STAFF REPORT
COMMUNITY DEVELOPMENT DEPARTMENT

HEARING DATE: 1/11/2022
 TO: Mayor & City Council
 FROM: Alan Tiefenbach
 208-884-5533
 SUBJECT: MDA, PP, RZ - H-2021-0086
 Apex East Subdivision
 LOCATION: Parcel #S1405120902, located on the south side of E. Lake Hazel Road between S. Locust Grove Road and S. Eagle Road

Request to rezone 32.21 acres of land from R-4 to the R-8 zoning district, development agreement modification to create a new DA to develop the proposed preliminary plat consisting of 97 residential building lots and 14 common lots.

Color Landscape Plan (date: 10/11/2021)

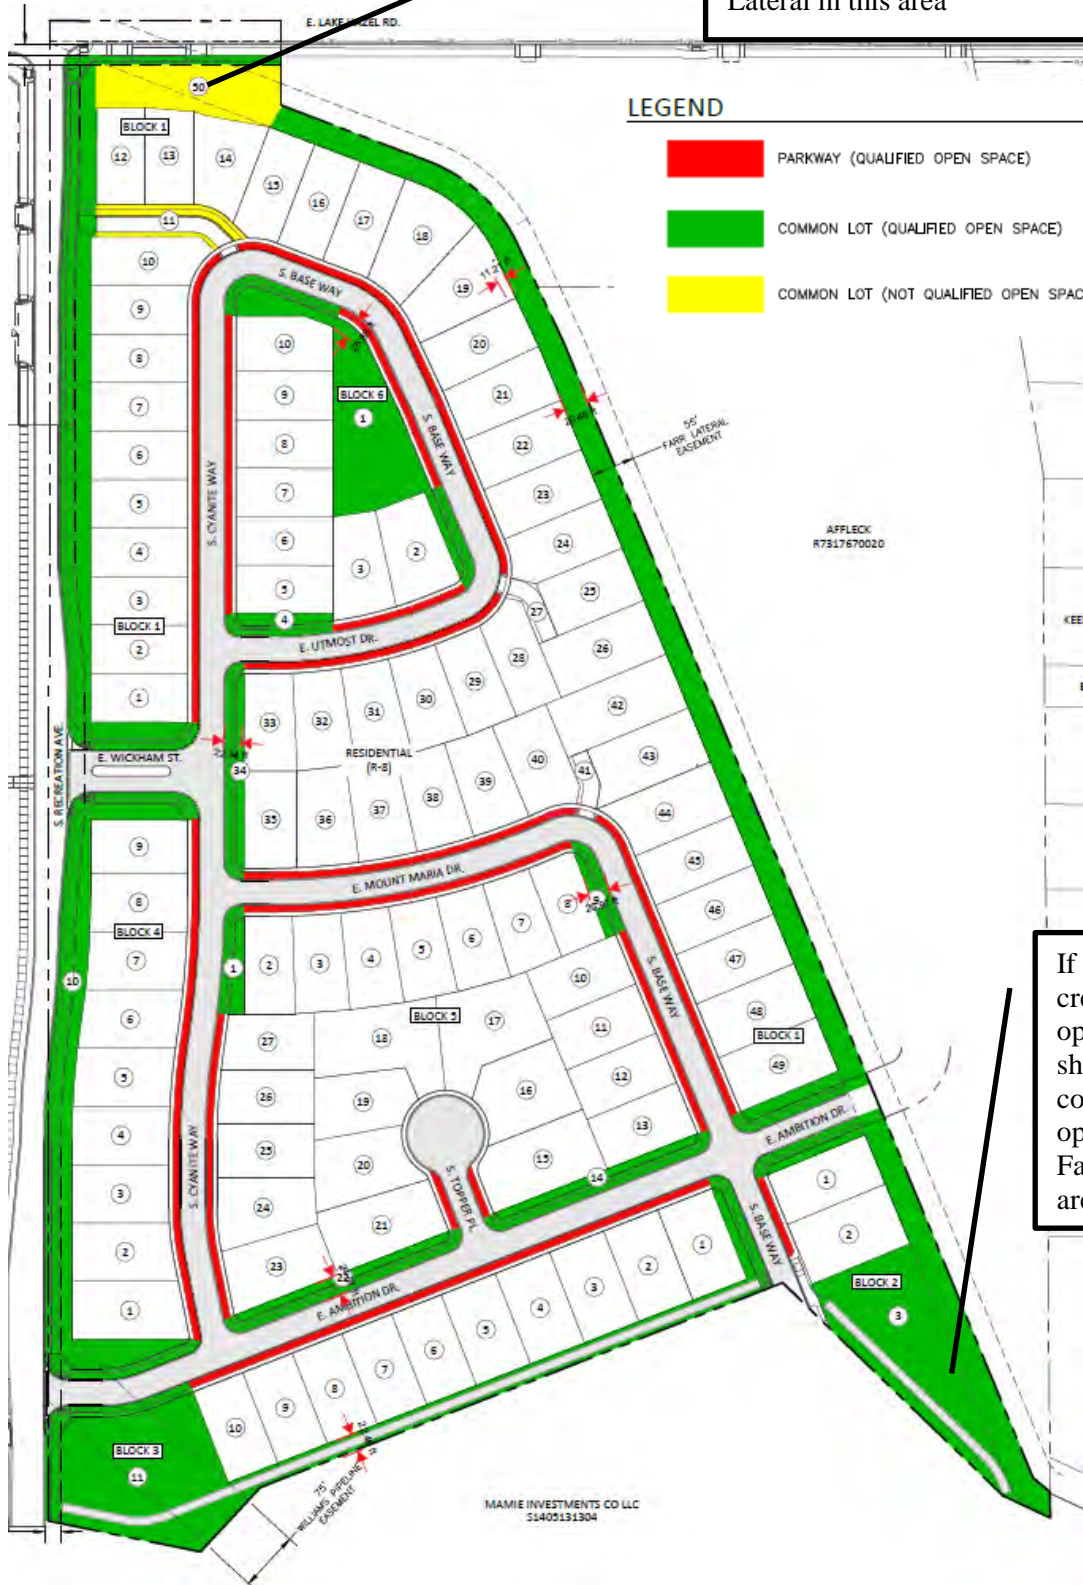
Staff does think the southern pathway (connecting to the Farr Lateral) should align with the eastern entrance into Discovery Park on the opposite side of S. Recreation Ave. (see the color landscape plan in Section VII). Staff has concerns the westernmost segment of the pathway will encourage people to cross S. Recreation Ave. out of a designated crosswalk or "cut across" the open space in the vicinity of the Williams Pipeline Easement. Staff recommends the plat and landscape plan be revised to provide a more direct and aligned connection between the southernmost pathway and the entrance into Discovery Park.

- e. ~~Prior to Commission, plat and landscape plan shall be revised to provide a more direct and aligned connection between the southernmost pathway and the entrance into Discovery Park at the west.~~

E. Common Open Space Exhibit (date: 10/11/2021)

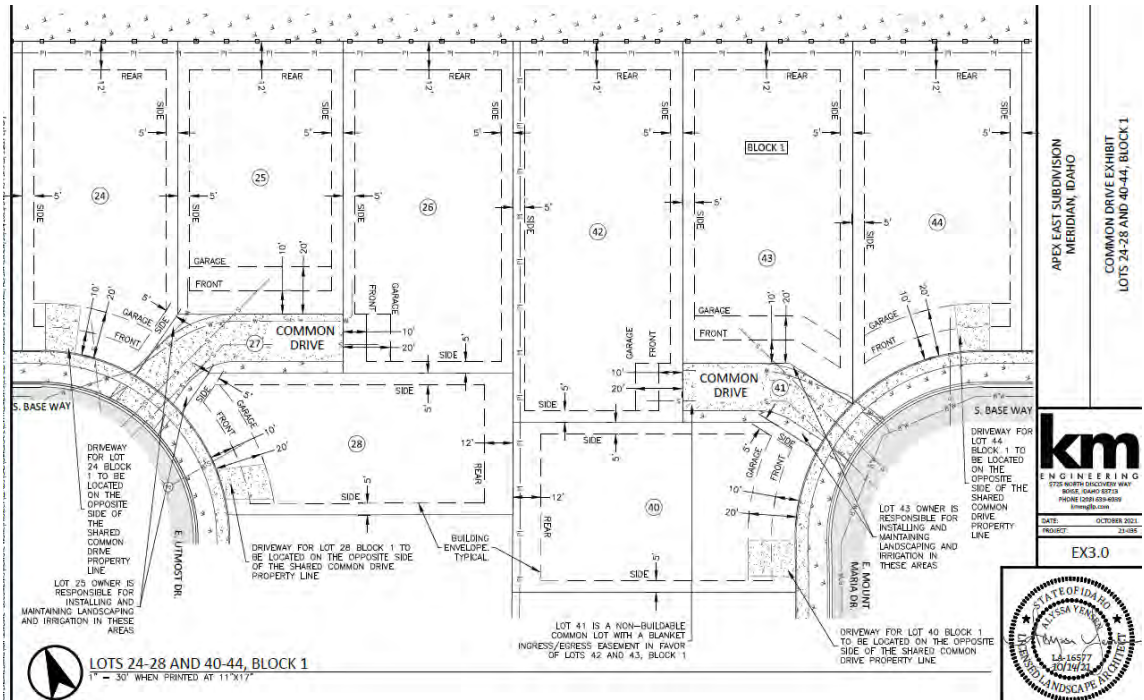
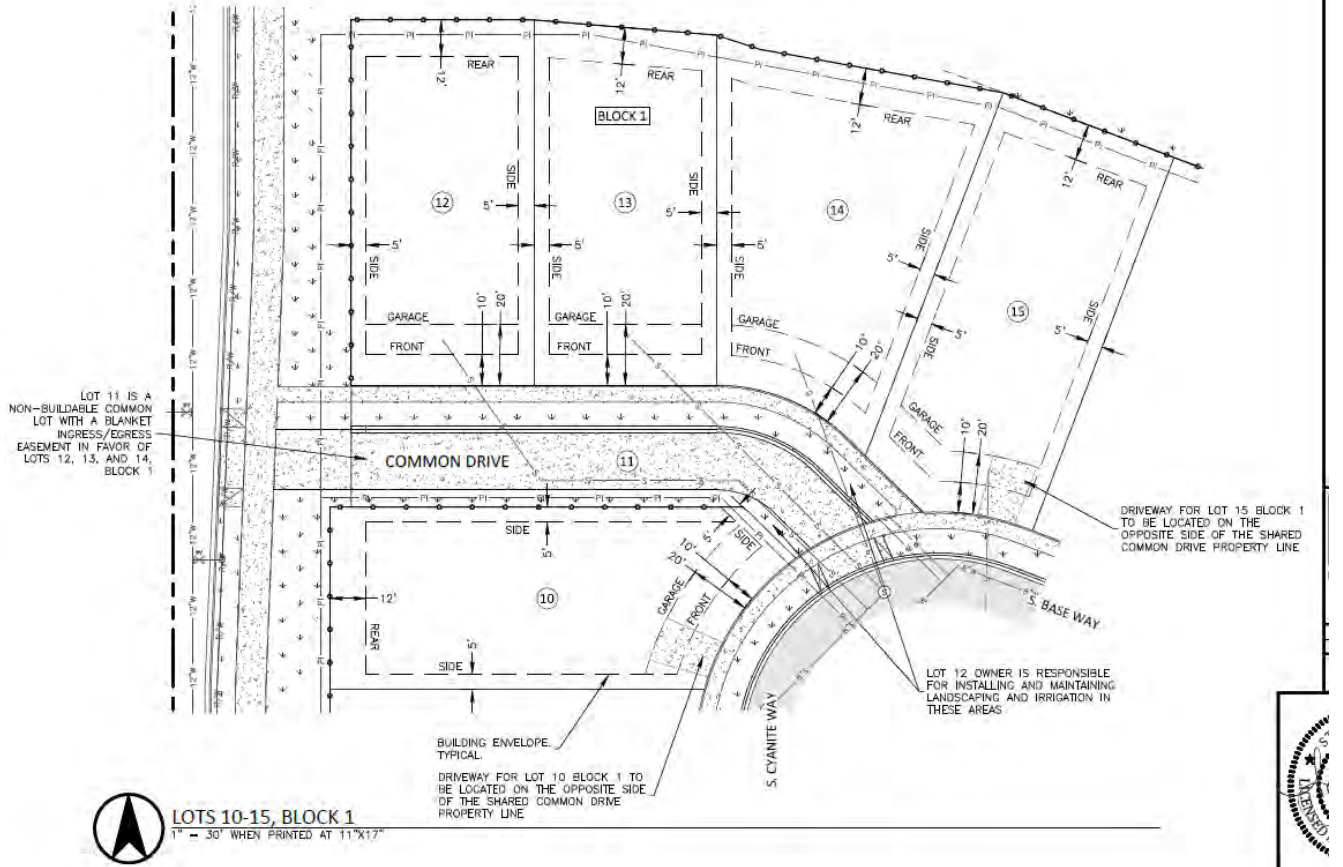
If this is going to be credited as qualified open space, there should be a connection to useable open space along the Farr Lateral in this area

If this is going to be credited as qualified open space, there should be a connection to useable open space along the Farr Lateral in this area
